***Board of Zoning Appeals Public Hearing
December 20, 2016 — 7:00 P.M***

CASE NUMBER:	V-16-025, V-16-026, V-16-027, V-16-028, V-16-029
PROPERTY LOCATION:	2000 Ray Moss Connector Johns Creek, GA 30222 1st District, 1st Section, Land Lot 153
CURRENT ZONING:	C-1 (Community Business) Conditional
PARCEL SIZE:	1.66 Acres
PROPERTY OWNERS:	Sankranti Restaurants
STAFF RECOMMENDATION:	APPROVAL WITH CONDITIONS

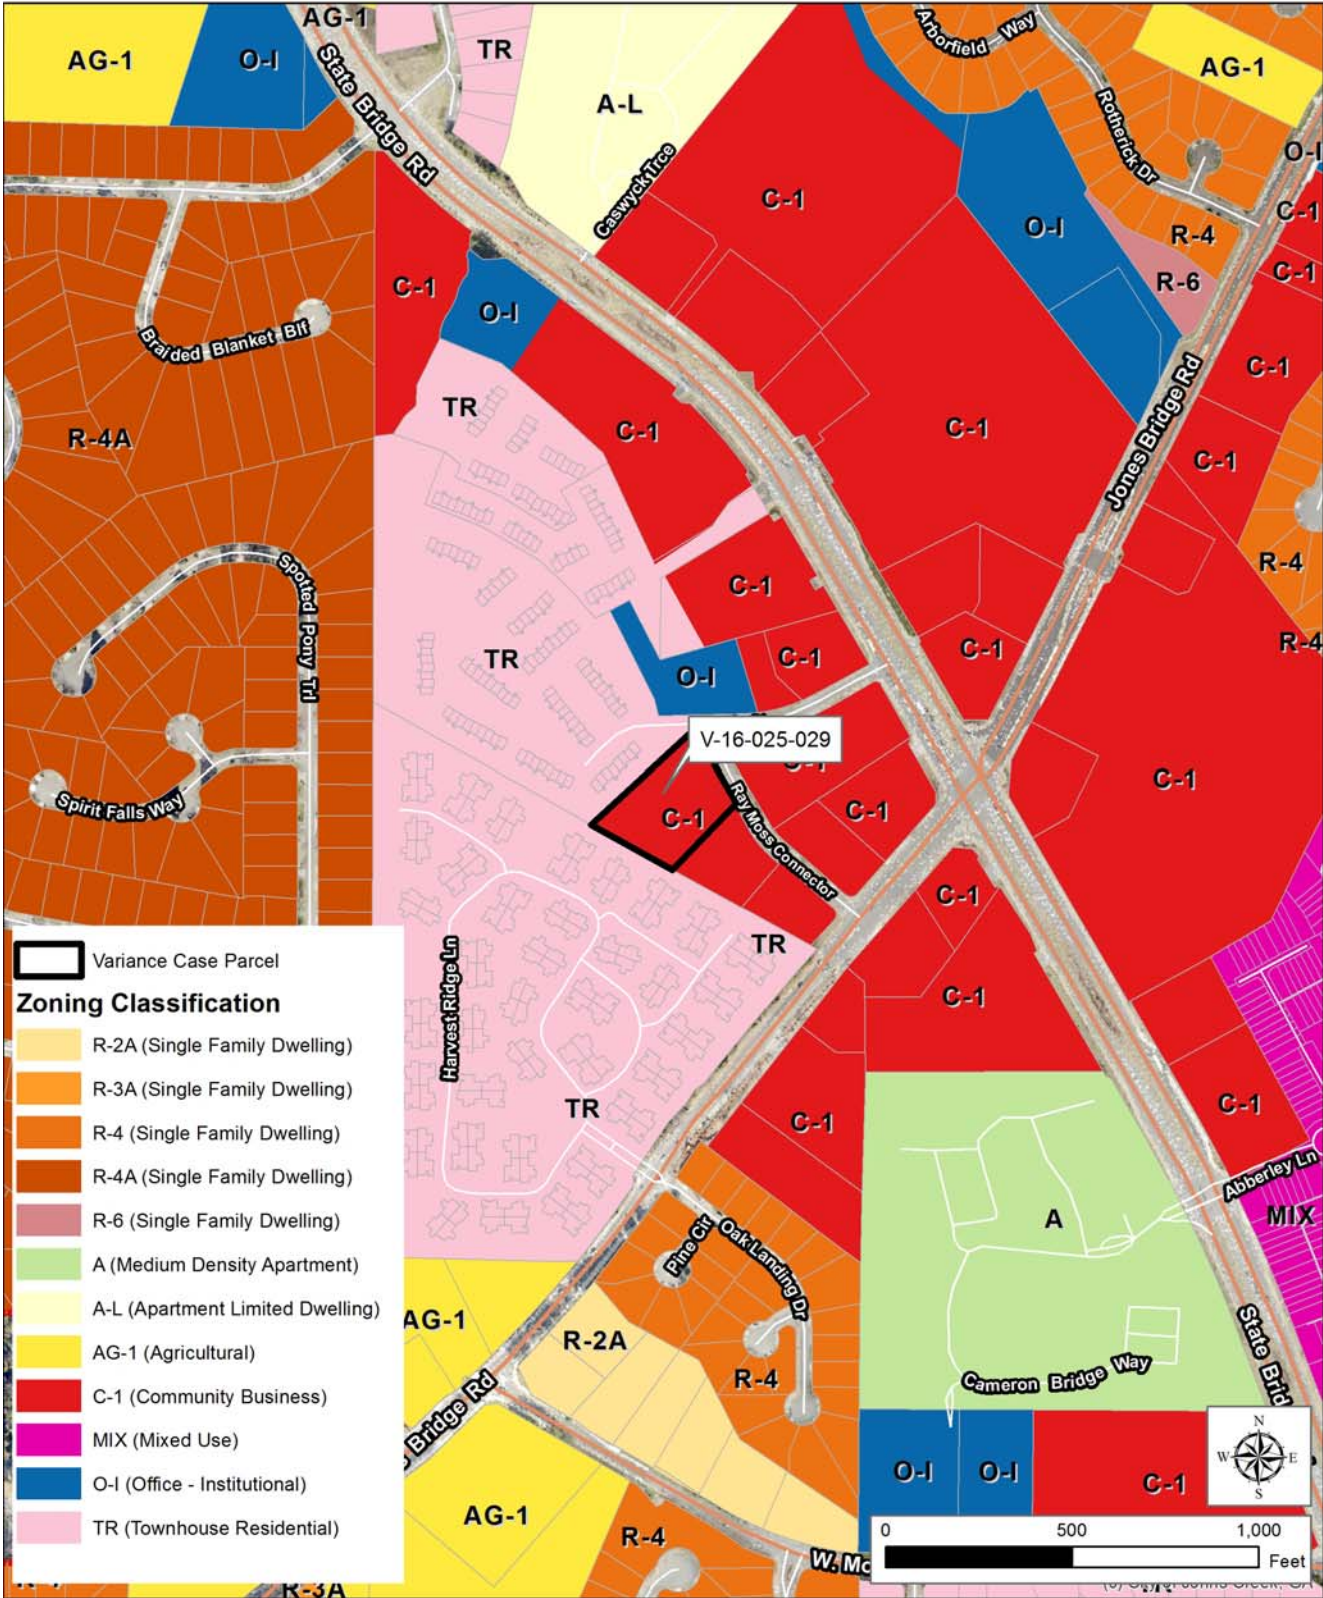
The fourth variance request V-16-028 is to allow proposed parking spaces to encroach into the 25-foot zoning buffer along the northwestern side of the property. The applicant has submitted a site plan with approximately 10 parking spaces in the 25-foot zoning buffer. Staff has suggested that the applicant re-work the site's parking lot layout so as to not encroach into the 25-foot zoning buffer on the northwestern side of the property, as there are alternative ways to lay out the parking that will not impact this buffer. **Therefore staff is recommending denial of V-16-028.**

The fifth variance request, V-16-029 is to allow a portion of four existing parking spaces and a portion of two proposed parking spaces to encroach into the 25 foot landscape strip along the northeastern side of the property, adjacent to Ray Moss Connector. Since the current parking layout currently has four parking spaces encroaching into the 25 foot landscape and a redesign of the parking lot would allow for the elimination of the existing detention basin, an additional eleven parking spaces and underground storm water detention **staff will recommend approval of V-16-029** as this is a minor encroachment of approximately 442 square feet (of which 342 square feet is already existing) into the 25-foot landscape strip.

V-16-028, if granted, would not be in harmony with the general purpose and intent of the Zoning Ordinance. Zoning buffers are intended to provide adequate separation between adjacent properties. In this case, allowing 10 parking spaces to be located in the 25-foot zoning buffer on the northwestern side of the property which is adjacent to a townhome community will not meet this intent.

V-16-029, if granted, would be in harmony with the general purpose and intent of the Zoning Ordinance. The revised layout of the site, as proposed by staff, would create a minor encroachment into the 25-foot landscape strip. There are four existing parking spaces, totaling approximately 342 square feet, that encroach into the 25-foot landscape strip and adding an additional 100 square feet of new impervious surface area for a portion of two new parking spaces would allow for a total of 442 SF into the 25' landscape which should have minimal impact on the streetscape of this secondary roadway.

1. Proposed cooler expansion shall encroach no more than 9' into the rear yard improvement setback.
2. Permit the applicant to access up to 62% of the required parking off-site from existing parking spaces that are located up to 500 feet from the property in compliance with the shared parking requirements of Section 18.2.2 of the Zoning Ordinance.
3. Obtain required building permits from the City of Johns Creek Community Development Department prior to commencement of construction.
4. No more than 2 new parking spaces and 4 existing parking spaces shall be allowed to encroach no more than a total of 442 square feet into the 25-foot landscape strip along the northeastern property line, adjacent to Ray Moss Connector, as proposed in the revised site plan recommended by staff.

1. No more than 8 parking spaces shall be allowed in the 25-foot zoning buffer along the northwestern property line, as shown on the site plan received November 2, 2016.
